## ORIGINATION FORM

Proposed Revisions to a Standard Plans Index  
(Please provide all information — Incomplete forms will be returned)

Index Number: 700-030  
Sheet Number (s): 1  
Index Title: Wind and Hanger Beams for Overhead Signs

**Summary of the changes:**

FRONT ELEVATION

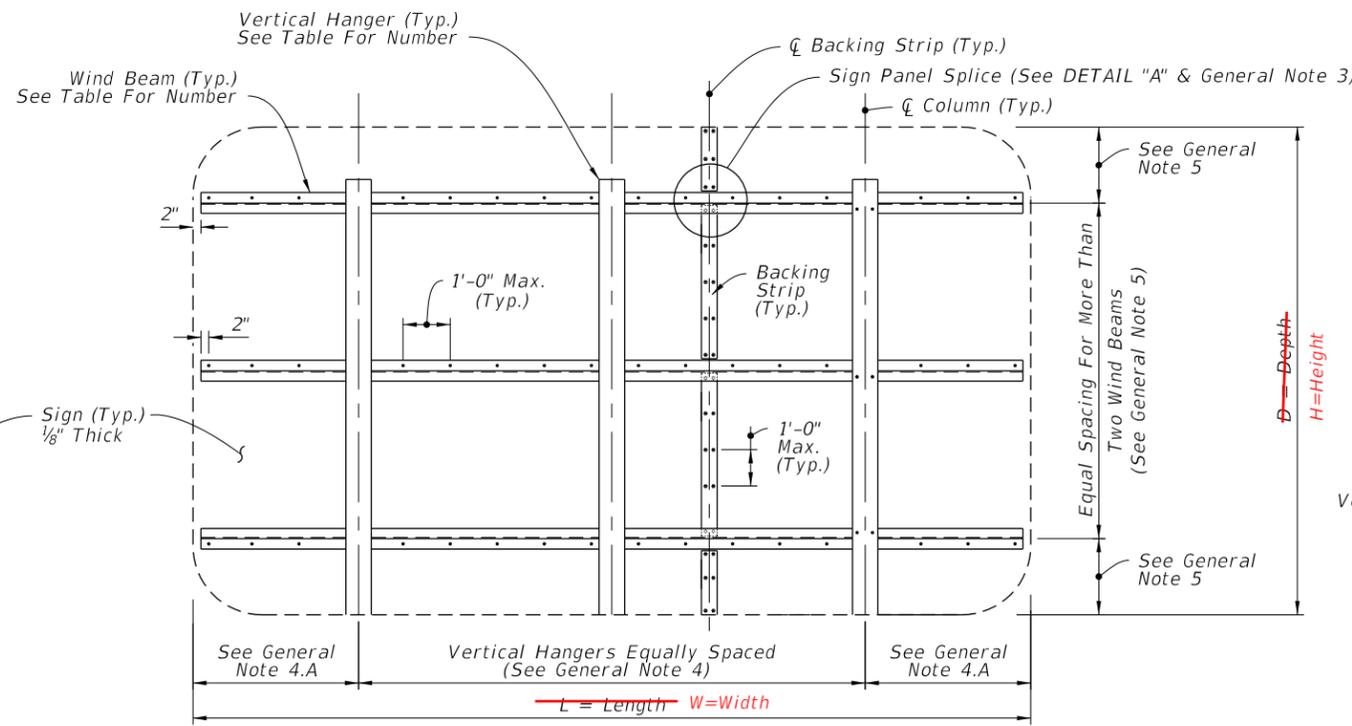
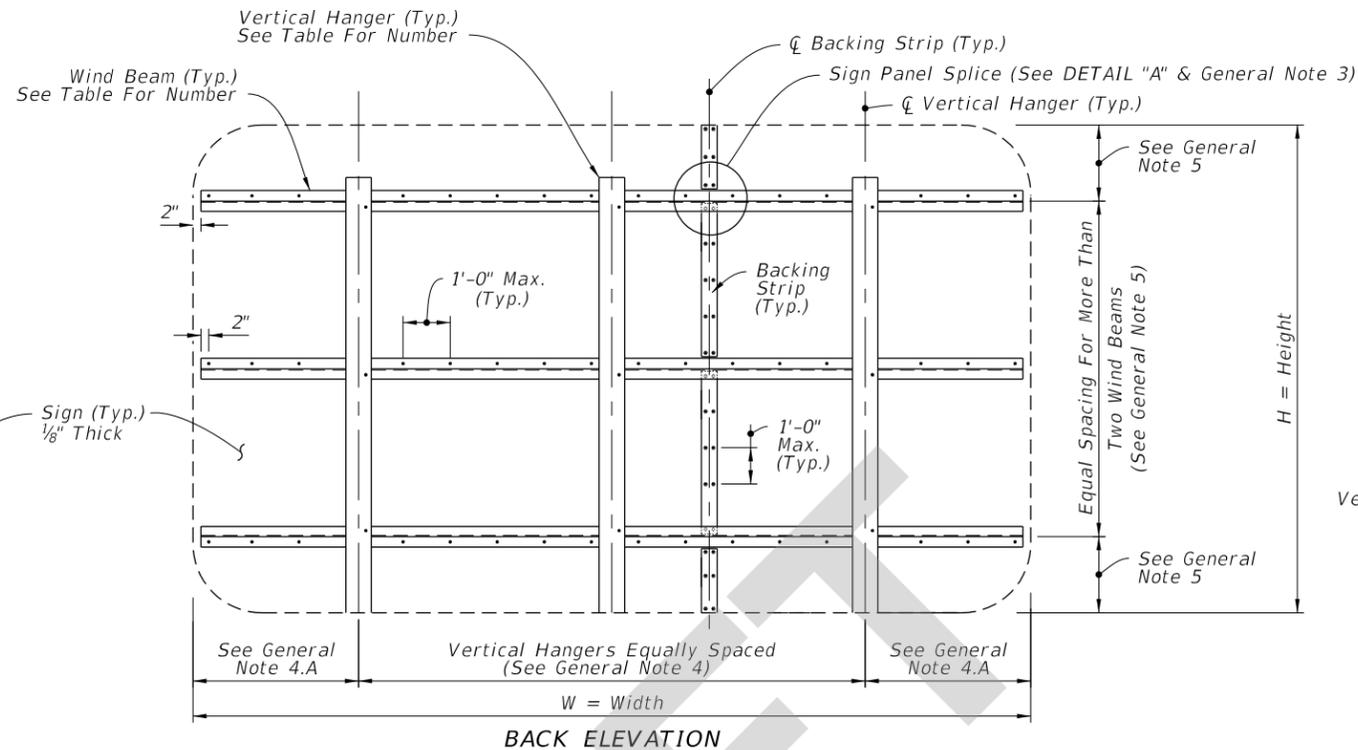
Changed all reference of length to width and all reference to depth to height.

The change is to be consistent with how the MUTCD dimensions signs. Section 700 and 995 will also need to be updated to be consistent with MUTCD.

DETAIL "B"

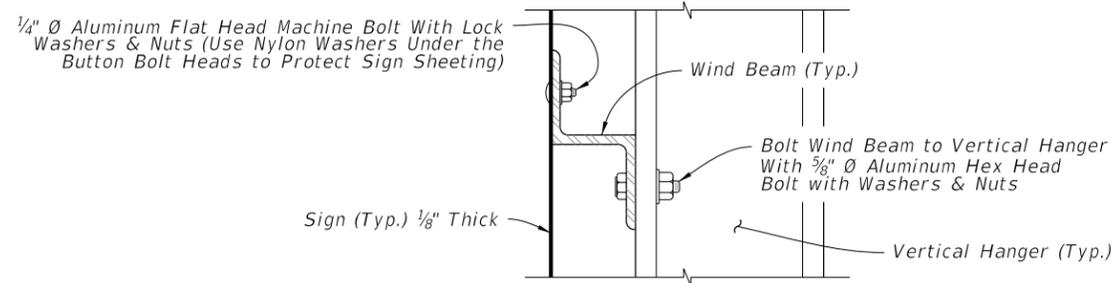
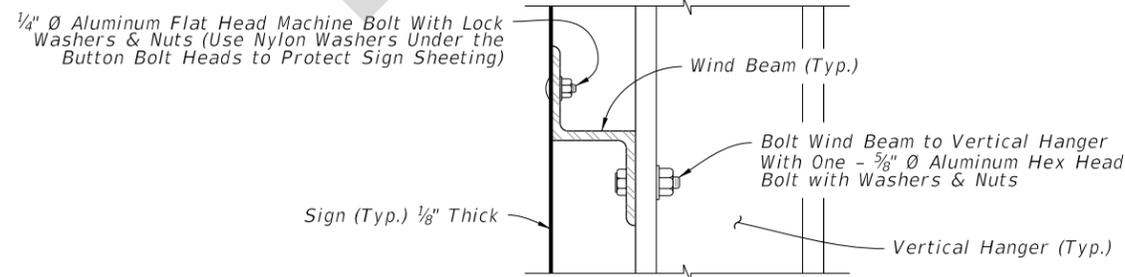
**WIND BEAM TABLE (Z 3 x 2 11/16 x 2.33)**  
Number of Horizontal Wind Beams Based on Sign Depth (D)

2 Beams	3 Beams	4 Beams	5 Beams	6 Beams
<del>D ≤ 5'</del>	<del>5' &lt; D ≤ 9'</del>	<del>9' &lt; D ≤ 12'</del>	<del>12' &lt; D ≤ 15'</del>	<del>15' &lt; D ≤ 18'</del>

CHANGED TO: Height (H)

**HANGER TABLE (I 6 X 4 x 4.69 or Z 5 x 3 1/4 x 4.01)**  
Number of Vertical Hanger Beams Based on Wind Speed and Sign Length (L)

2 Hangers	3 Hangers	4 Hangers	5 Hangers	6 Hangers
130 mph	<del>L ≤ 20'</del>	<del>20' &lt; L ≤ 30'</del>	<del>30' &lt; L ≤ 40'</del>	<del>40' &lt; L ≤ 50'</del>	--
150 mph	<del>L ≤ 18'</del>	<del>18' &lt; L ≤ 27'</del>	<del>27' &lt; L ≤ 35'</del>	<del>35' &lt; L ≤ 45'</del>	<del>45' &lt; L ≤ 50'</del>
170 mph	<del>L ≤ 15'</del>	<del>15' &lt; L ≤ 20'</del>	<del>20' &lt; L ≤ 28'</del>	<del>28' &lt; L ≤ 35'</del>	<del>35' &lt; L ≤ 43'</del>

CHANGED TO: Width (W)

WIND BEAM TABLE (Z 3 x 2 <sup>11</sup> / <sub>16</sub> x 2.33)					
Number of Horizontal Wind Beams Based on Sign Height (H)					
2 Beams	3 Beams	4 Beams	5 Beams	6 Beams	
H ≤ 5'	5' < H ≤ 9'	9' < H ≤ 12'	12' < H ≤ 15'	15' < H ≤ 18'

HANGER TABLE (I 6 X 4 x 4.69 or Z 5 x 3 <sup>1</sup> / <sub>4</sub> x 4.01)					
Number of Vertical Hanger Beams Based on Wind Speed and Sign Width (W)					
	2 Hangers	3 Hangers	4 Hangers	5 Hangers	6 Hangers
130 mph	W ≤ 20'	20' < W ≤ 30'	30' < W ≤ 40'	40' < W ≤ 50'	--
150 mph	W ≤ 18'	18' < W ≤ 27'	27' < W ≤ 35'	35' < W ≤ 45'	45' < W ≤ 50'
170 mph	W ≤ 15'	15' < W ≤ 20'	20' < W ≤ 28'	28' < W ≤ 35'	35' < W ≤ 43'
